PERMIT

SEWAGE DISPOSAL SYSTEM

A REPAIR

PROPERTY OWNER Howard H. Grove

INDICATE NORTH - NAME ADJOINING ROADWAY AS BASE LINE.
 FOREST HILL DR

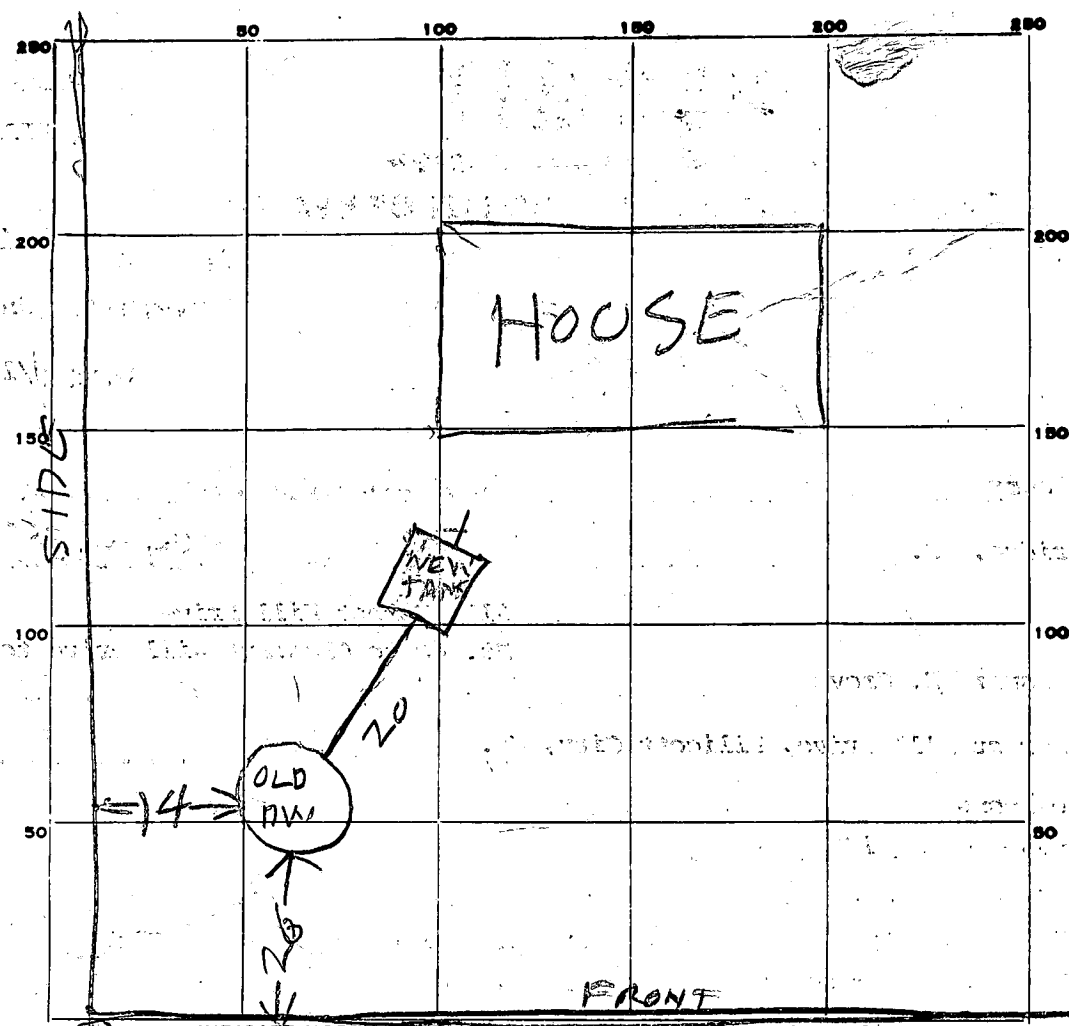
REMARKS 9/19/79 NEW CONCRETE TANK INSTALLED TO REPLACE
OLD RUSTED STEEL TANK. CITY WATER HERE. INSTALL
MANHOLE ON TANK & CLEANOUT ON DW & CALL. OK TO
COVER SEWER LINE RH 9/20/79 CLEANOUTS PUT ON
TANK & DRY WELL BUT NOT MANHOLE TFF SAID
MANHOLE NOT NEEDED IN THIS CASE ON 9/21/79
